NP-12-0001
February 6, 2012

Subject: Exelon Nuclear Texas Holdings, LLC
Victoria County Station Early Site Permit Application
Response to Request for Additional Information Letter No. 14
NRC Docket No. 52-042

Attached is the response to the NRC staff question included in Request for Additional Information (RAI) Letter No. 14, dated December 13, 2011, related to Early Site Permit Application (ESPA), Part 2, Section 02.05.01. NRC RAI Letter No. 14 contained one (1) Question. This submittal comprises the complete response to RAI Letter No. 14, and includes response to the following Question:

02.05.01-22

Figure 1. Geologic Features of the Gulf Coast Region with the Locations of the October 20, 2011 Mw 4.8 and November 12, 2011 Mw 3.3 Earthquakes

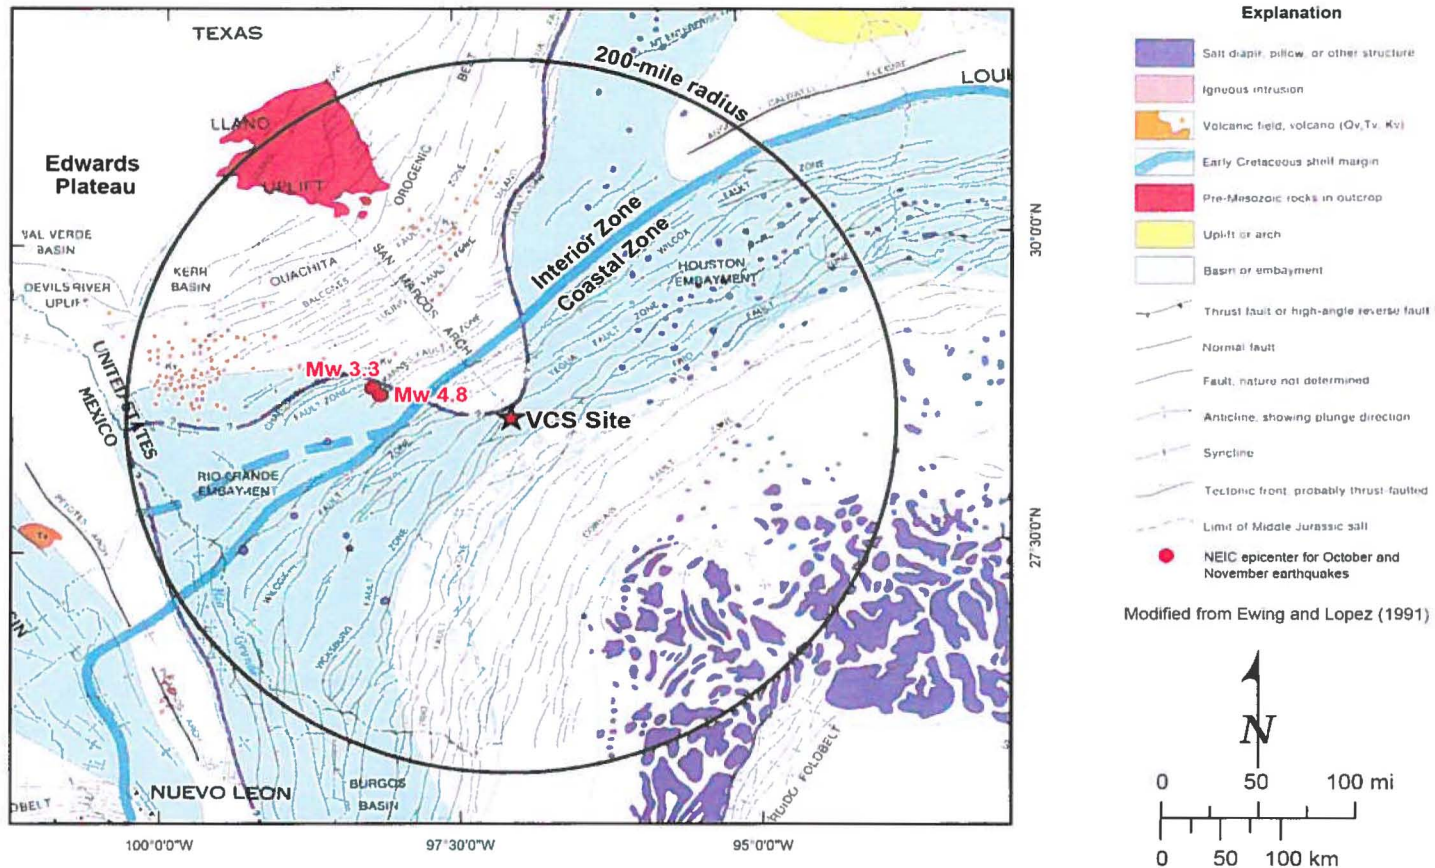
Provide a discussion that examines the Texas earthquakes (October 20 and November 12, 2011) and implications for a VCS regional tectonic feature that might be considered a capable fault that originates within the Ouachita basement rock, beneath the Gulf Coast Coastal Plain sedimentary section. Include in your discussion the alternative possibilities that the Texas earthquake is induced or that it is a small seismic event on an active growth fault. Additionally, consider and discuss the possibility of an error in the location of the earthquake and the implications that a location error could have on all the above and related event fault and source interpretations.

Question 1: Provide a discussion that examines the Texas earthquakes (October 20 and November 12, 2011) and implications for a VCS regional tectonic feature that might be considered a capable fault that originates within the Ouachita basement rock, beneath the Gulf Coast Coastal Plain sedimentary section.

The October Mw 4.8 and November Mw 3.3 earthquakes are located near Fashing, Texas, in an area of the Coastal Plain that has experienced several small to moderate earthquakes in the past approximately 40 years (Figure 1). As explained below, researchers studying past earthquakes in this area argue this seismicity is most likely induced by human activities (Davis, et al., 1995; Pennington, et al., 1986), and all information available suggests that the 2011 events are most likely induced by human activity as well.

The Mw 4.8 and 3.3 events are located along the western margin of the San Marcos arch adjacent to the Charlotte-Jourdanton fault zone (CJFS) and the Karnes fault zone (KFS) (Figures 1 and 2). As discussed in SSAR Subsection 2.5.1.1.4.3.3, the CJFS and KFS (along with the Mexia-Talco, Milano, and Mt. Enterprise-Elkhart Graben fault systems) are a part of the Mesozoic fault systems of the Gulf of Mexico region and are interpreted as being related to bodies of Jurassic salt at depth (SSAR Figures 2.5.1-11 and 2.5.1-12) (Ewing, 1991; Murray, 1961). In general, these fault systems are updip of, and sole into, salt pinchouts or welds, and motion on the faults is related to salt migration that formed the welds and pinchouts (Diegel, et al., 1995; Nelson, 1991).

The October 20, Mw 4.8, and November, 12 Mw 3.3, Texas earthquakes were located approximately 70 miles west-northwest of the VCS Site near Fashing, Texas (Figure 1). The U.S. Geological Survey National Earthquake Information Center (NEIC) reports that the October 20, 2011, Mw 4.8 event was located at 28.806°N, 98.147°W—approximately one mile north-northwest of the town of Fashing, Texas, with an uncertainty of 12 miles (19.3 km) and an estimated depth of 1.9 miles (3 km) (with ± 1.9 miles [3.1 km] uncertainty; Figure 2) (USGS, 2011b). The double-couple focal mechanism for the Mw 4.8 event includes a generally northeast-oriented (053° and 241°) solution dipping either 72° south-southeast or 18° north-northwest.

Figure 2. Map of Fashing Area Illustrating October and November Earthquakes, Oil and Gas Wells, and Faults

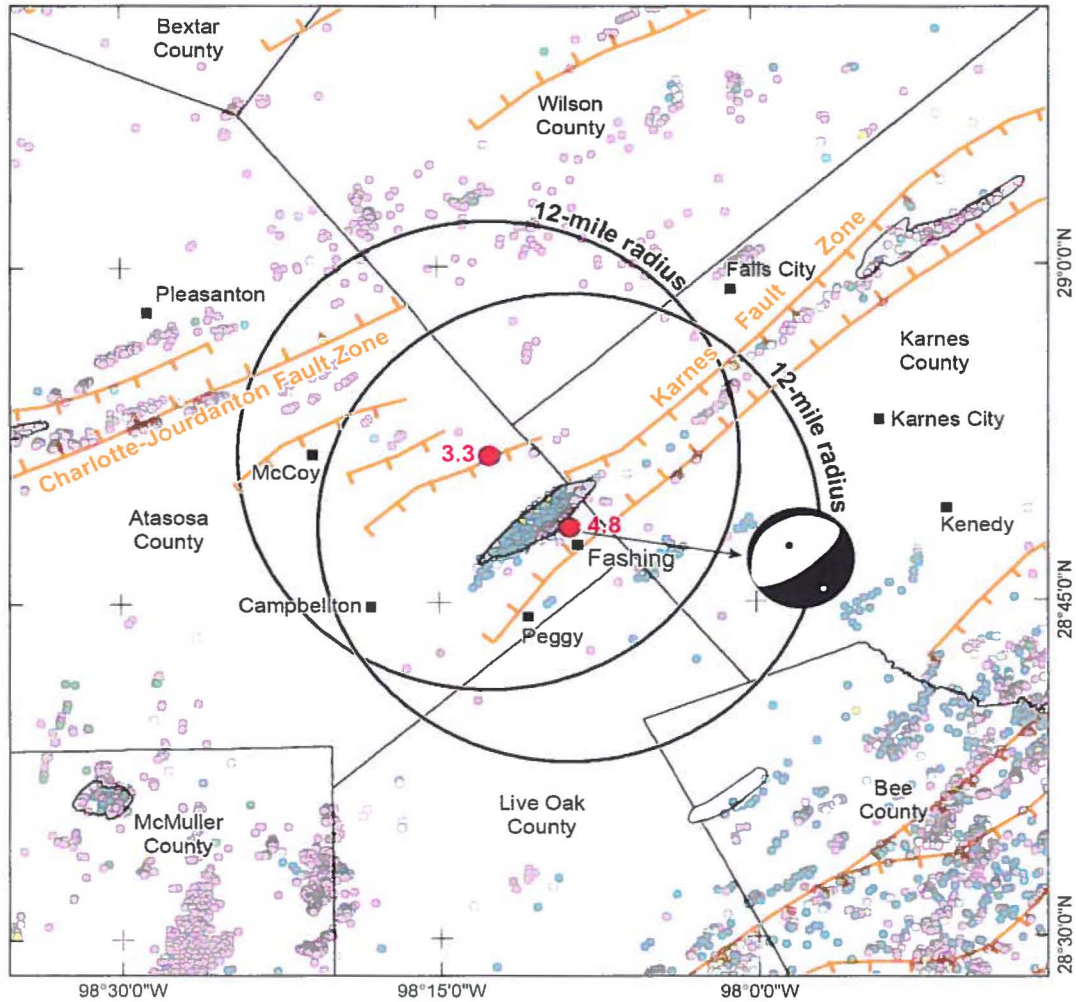
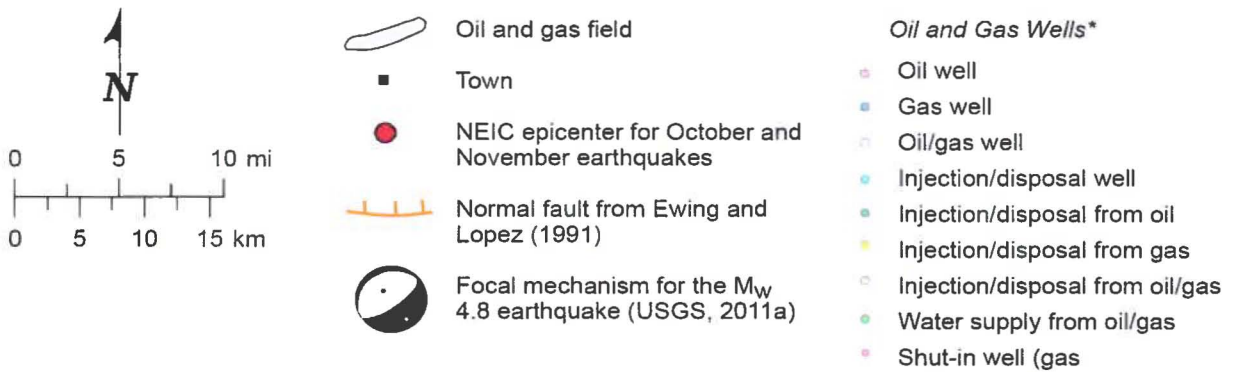
Question 3: Additionally, consider and discuss the possibility of an error in the location of the earthquake and the implications that a location error could have on all the above and related event fault and source interpretations.

From firsthand accounts, Mr. Brunt concluded that the most intense shaking—a proxy for the epicenter (e.g., the Modified Mercalli Intensity Scale)—occurred within an area of approximately 6 miles west-northwest and 5 miles southwest of the reported epicenter of the USGS (Figure 2) (Brunt, 2011; USGS, 2011b). The most intense felt report was on the north side of CR 407 and 1.6 miles northeast of FM 1099, near the town of Peggy (Figure 2). Residents within this general area observed cabinet doors opening, pictures and items falling, items moving, and sheet wall damage. Mr. Brunt noted numerous new oil and gas operations within the vicinity of the most intense shaking. In contrast, closer to the location of the U.S. Geological Survey's reported epicenter, residents experienced only "light to moderate" shaking and an absence of falling objects. The most profound effects felt by residents near the reported epicenter apparently included audible noises, difficulty walking, and trouble standing during the shaking. This research is ongoing, should be considered preliminary and may change after further review by Dr. Frohlich or Mr. Brunt.

“Yes” for both the October and November events. Figure 2 clearly illustrates that both epicenters are located within 5 km of an active well.

As discussed above, the epicenter for the November Mw 4.8 event provided by the USGS is poorly constrained with a 12 mile uncertainty (Figure 2) (USGS, 2011a, b). The Mw 3.3 event is small enough that the USGS does not provide an estimate of epicentral uncertainty. The discussion below focuses on the uncertainty associated with the Mw 4.8 event. An unpublished felt report for the November Mw 4.8 earthquake helps to constrain the location of the event and suggests it may have been located near Peggy, Texas (Brunt, 2011). This location is within the 12-mile uncertainty provided by the USGS and helps to constrain location of the epicenter. Even if the event occurred at the limits of the reported error (12 miles from the USGS epicenter), the October earthquake would not be located on a fault zone other than the CJFZ or the KFZ (Figure 2). Thus, consideration of the epicentral uncertainty for the Mw 4.8 event does not change the response provided above (i.e., addressing Questions #1 and #2).

The depth assignment for the Mw 4.8 and Mw 3.3 events are poorly constrained (Cliff Frohlich, personal communication, 2011). The 3 km depth of the Mw 4.8 earthquake provided by the USGS had a reported uncertainty of 3 km and no depth was provided for the Mw 3.3 event (Figure 2). The depth to Ouachita basement bedrock in the epicentral area is 5 to 6 km and, given the limits of the depth uncertainty, the hypocenter could have been located within basement. However, this appears to be unlikely based on the estimated hypocentral depths for past earthquakes from isoseismals (Davis, et al., 1995). Davis et al. (1995) argue that the intensity and limited extent of the strong ground shaking for the 1993 m_{bLg} 4.3 earthquake suggest the event was likely shallow (i.e., located above basement). Based on this analogy, the Mw 4.8 event likely occurred within the Mesozoic and Tertiary sedimentary section above basement rock. This interpretation is consistent with the hypothesis that the Mw 4.8 event was induced by fluid extraction and/or injection.

Figure 3. Location of Major Gas Field in the Fashing Area

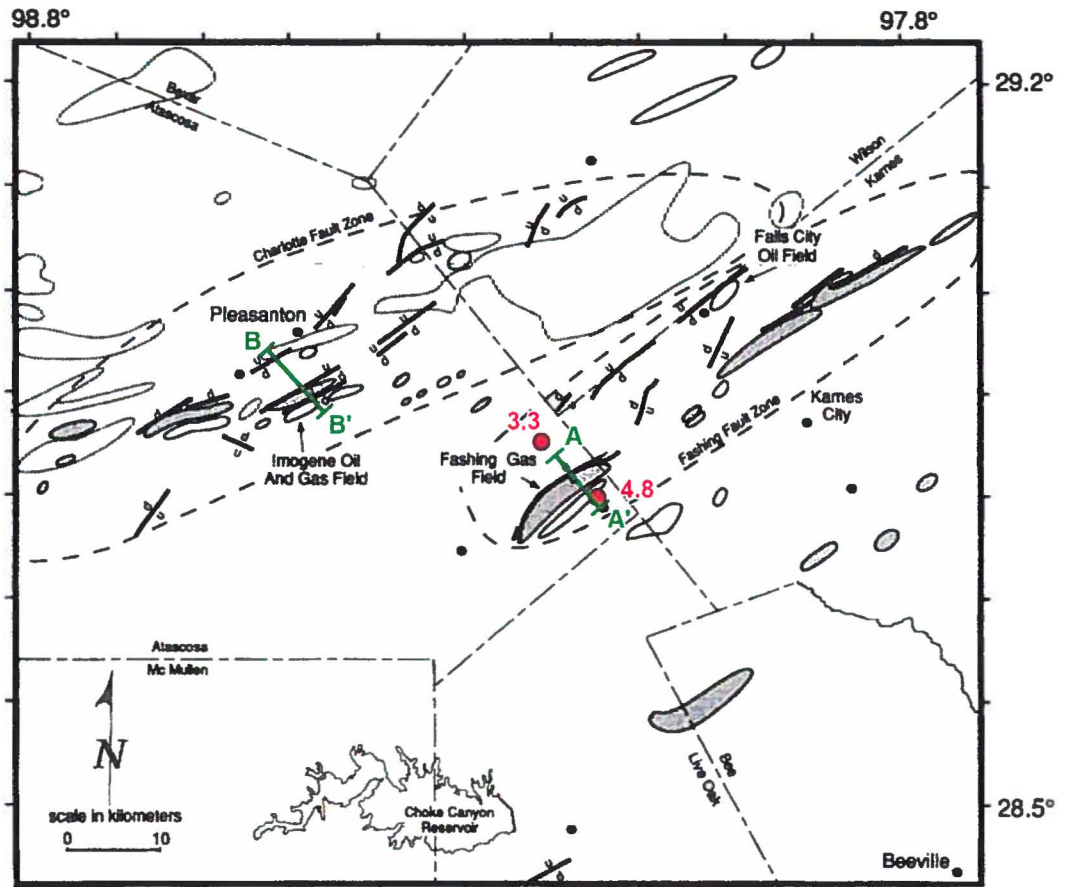
Question 2: Include in your discussion the alternative possibilities that the Texas earthquake is induced or that it is a small seismic event on an active growth fault.

Seismicity can be induced (or caused by human-related activities) through primarily two activities: 1) construction of large reservoirs or 2) fluid extraction or injection. The October and November earthquakes are not located near a large surface-water reservoir. The closest such reservoir is more than 20 miles southwest (Figure 3). Thus, these earthquakes were most likely not related to a surface-water reservoir.

The October 20, 2011, Mw 4.8 earthquake is located near the southeastern edge of the Fashing gas field, and the November 11, 2011, Mw 3.3 event is located near the northwest edge of the field (Figure 3). Given the spatial association of the Mw 4.8 October 20, 2011, event with the horizontal and vertical position (3 km depth) of the gas field, coupled with the 1993 m_{bLg} 4.3 Fashing earthquake and subsequent publications suggesting an induced earthquake mechanism (Davis, et al., 1995), it is probable that the October 20, 2011, earthquake was induced by gas field activity and likely reactivated the nearest growth fault (i.e. the KFS; see results summarized in Table 1). At the same time, it cannot be scientifically precluded that the October 20, 2011, event resulted from natural earthquake stress relief along shallow growth faults overlying the Paleozoic basement rocks (i.e., the KFS). However, the spatial coincidence with the Fashing Gas Field and the previous occurrence of withdrawal-induced seismicity in the epicentral area, based on consensus from review of the peer-reviewed literature, suggests that the most likely cause is fluid withdrawal in the subsurface (Table 1).

Figure 4. Cross Section across the Fashing Gas Field and Imogene Oil Field.

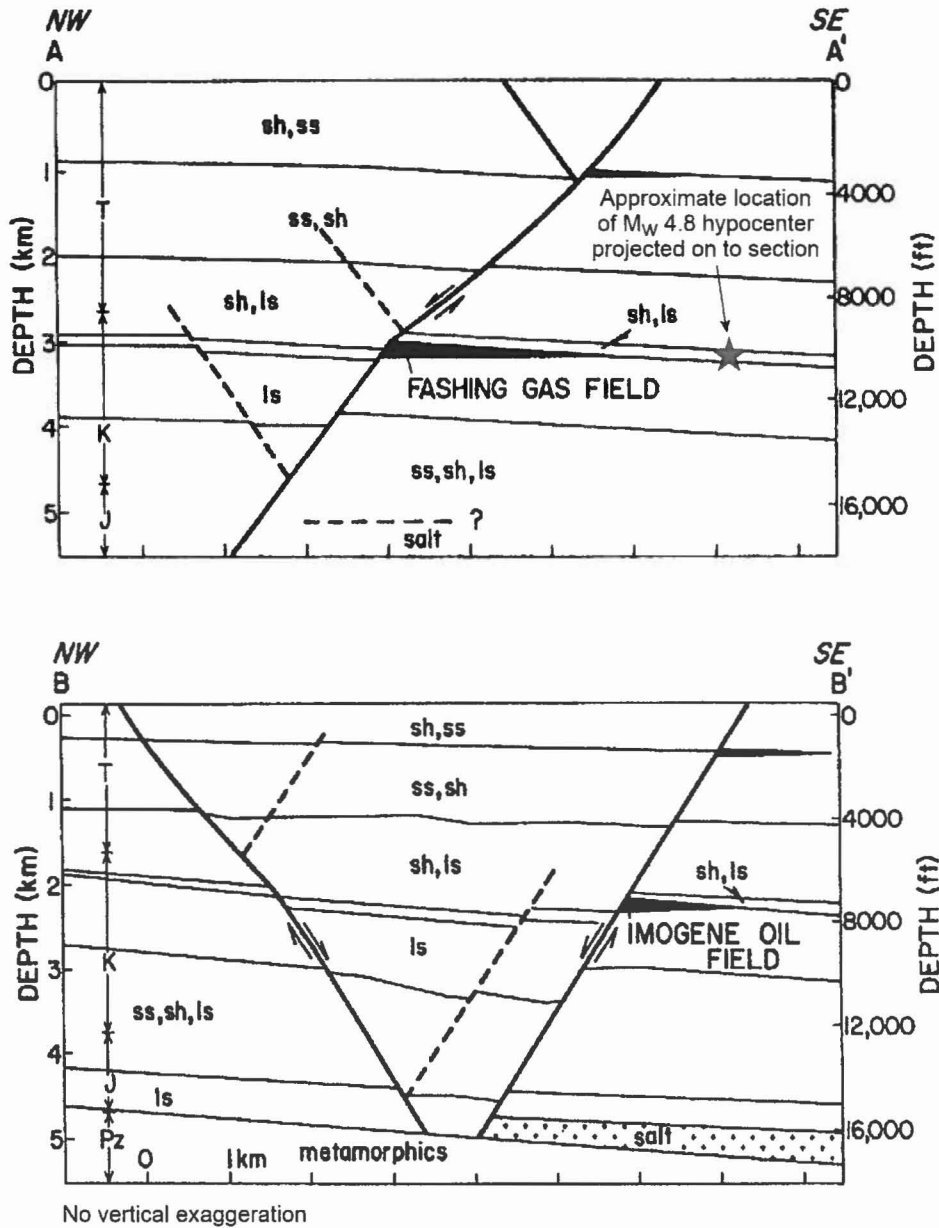
(2b): Do some earthquakes occur at or near production depths?

Tentative “Yes” for the October earthquake and uncertain (“?”) for the November event. Production depths at the Fashing gas field occur at approximately 3 km depth (Figure 4), which is similar to the approximately 3 km depth assigned by the USGS (2011a) and for past events based on isoseismals (e.g. 1993 event) (Davis, et al., 1995). In addition, the October 2011 event plots very closely to the KFS (shown in Figure 4) suggesting the earthquake likely occurred on this fault, very near the production area. The uncertainty associated with the depth of the November event make it difficult to provide a definitive answer on this question.
